Renovations to the Putnam County Governmental Complex Bid # 07-14

May 14, 2007

ADDENDUM #4

BLDG P CEILING DETAIL

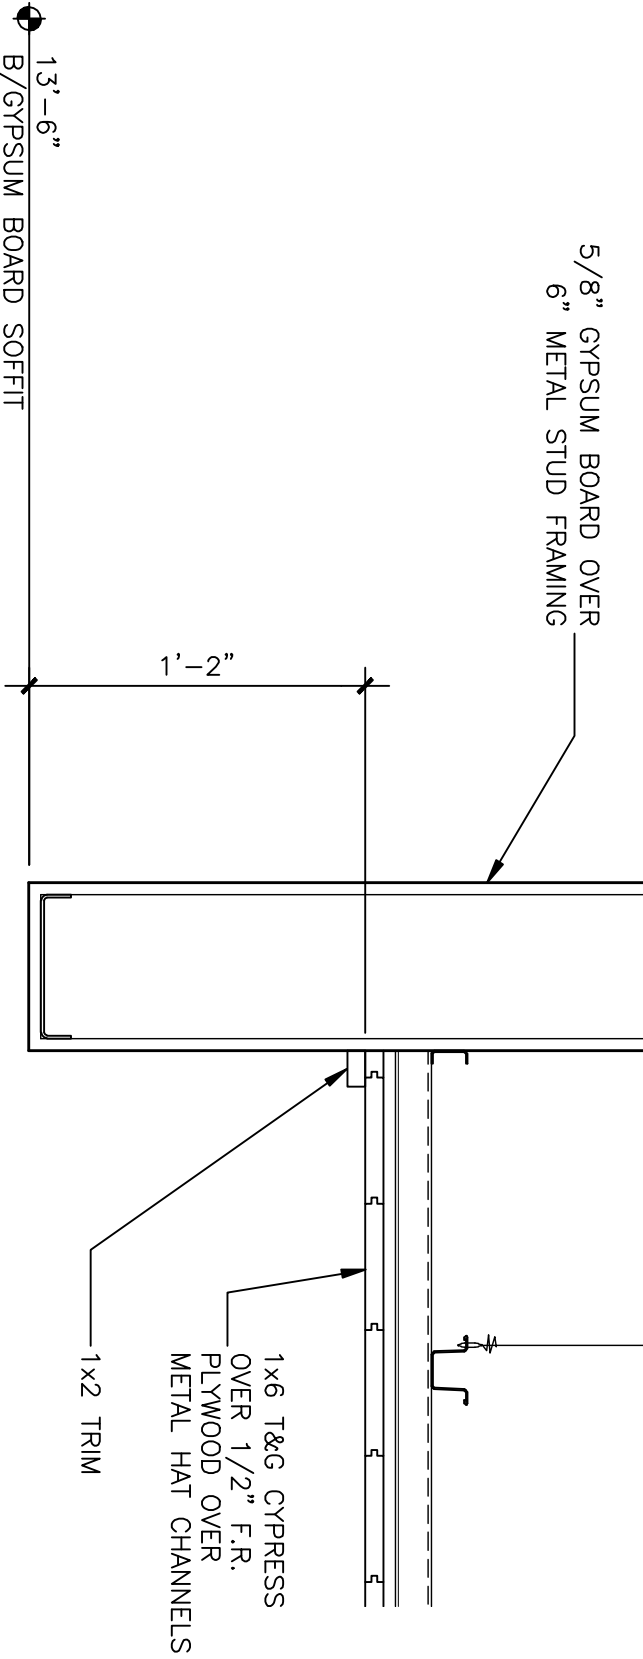
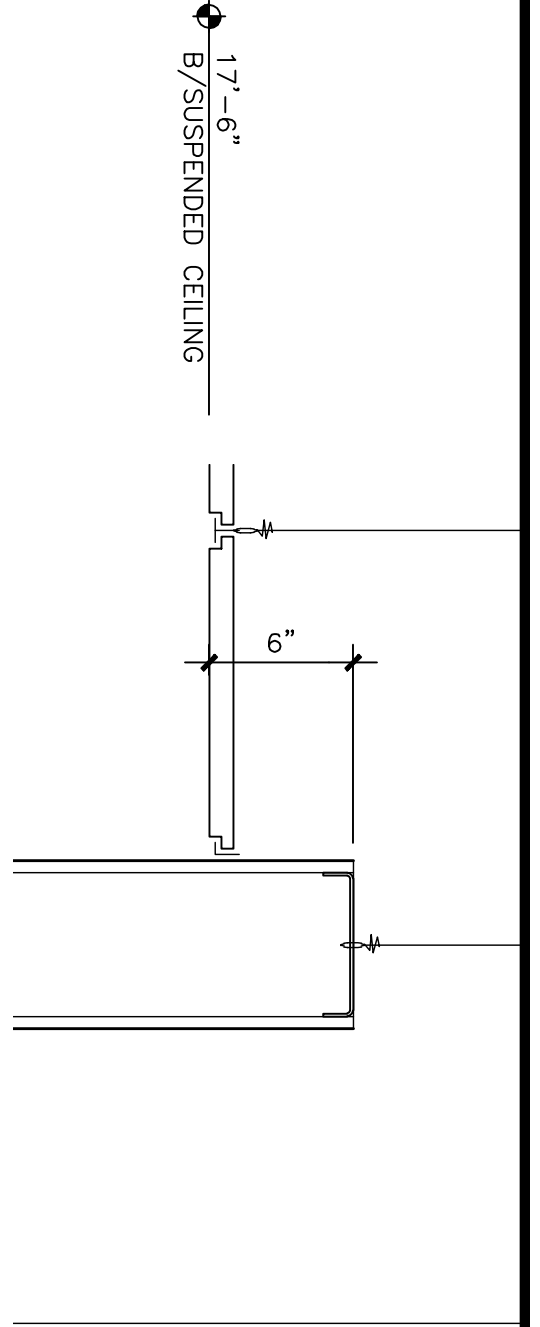
- 4.7 Ceiling Finishes: These shall be as indicated on the lighting plans. Note locations of wood ceilings in Building P at P100 & P112.
- 4.8 Insulation: Provide tapered insulation as required to achieve positive drainage. Install R-30 batts above suspended ceiling in all spaces to be renovated.

- 4.33** A0.3: Clarification: Provide aluminum canopy as specified & as shown on sheet A0.8
- 4.34** A1.2: Clarification: The wood ceilings are limited to the rectangular area in the center of Lobby P100 & over the commission dias, behind the curved soffit in P112. Reference the attached ceiling details as well. Reference lighting plans and finish schedules for ceiling information.
